SUBJECT: Notice of Noncompliance – Spreading near a Direct Conduit to Groundwater

The Department received a complaint on July 27, 2010 through the Kewaunee County Land and Water Conservation Department (LWCD) regarding landspreading of solid manure on NOW-1 and NOW-2, N ½ NE ¼ S6 T25N R24E in the Town of Lincoln, Kewaunee County.

Town of Lincoln
NE 1/4 of Section 6, T.25N.-R.24E.

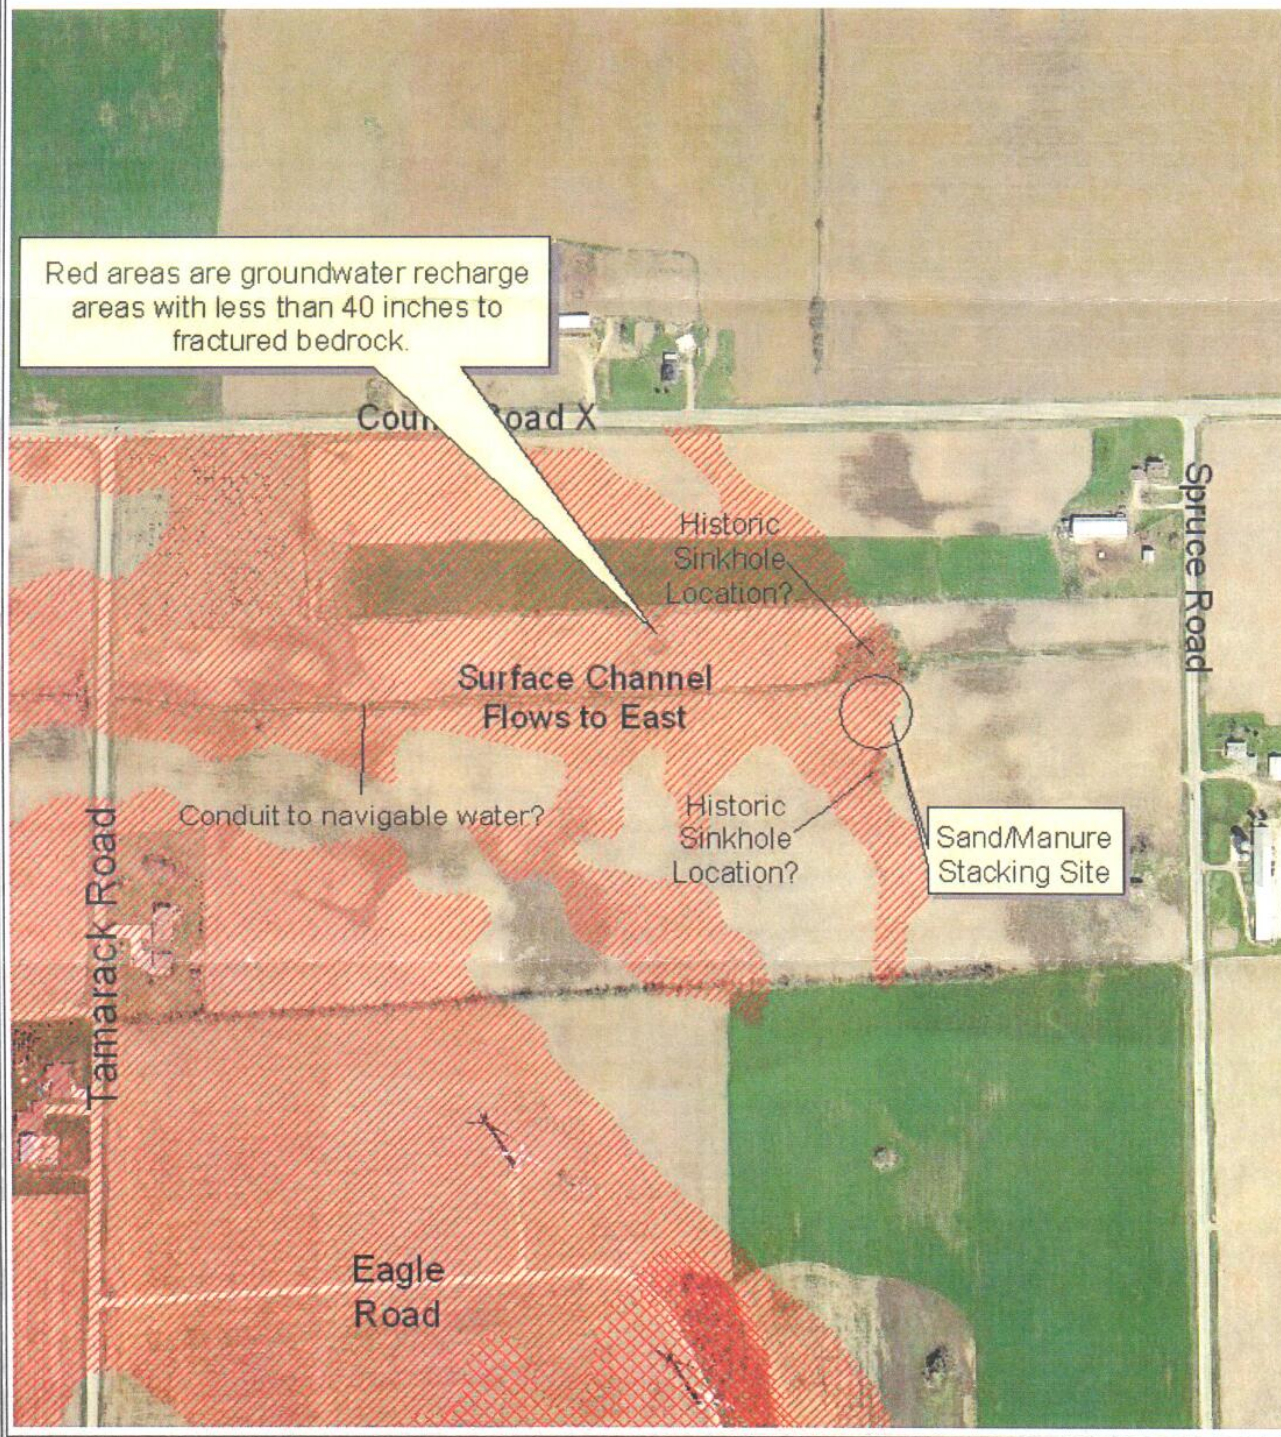
Based on information provided to the Department, a number of features identified in NOW-1 and NOW-2 as well as RWM-1, RWM-2, RWM-3, RWM-4, and RWM-5 have been identified through as sinkholes. Please review the enclosed maps identifying the location of the features. Under NR 243.14 (2)(b)8, manure or process wastewater may not be applied within 100 feet of a direct conduit to groundwater. A sinkhole is considered a direct conduit to groundwater under NR 243.03 (20).

Please submit updated spreading restriction maps for fields NOW-1, NOW-2, RWM-1, RWM-2, RWM-3, RWM-4, and RWM-5 identifying spreading restrictions around the sinkholes as well as any other spreading restriction on the field by Friday, August 13, 2010. The Kewaunee County LWCD may be available to assist with best management practices for fields with direct conduits to groundwater as well as provide assistance in verifying the location of the sinkholes in these fields to ensure compliance with your WPDES permit. Please contact Andy Wallander, Kewaunee County Conservationist, at (920) 845-1360 to discuss options.
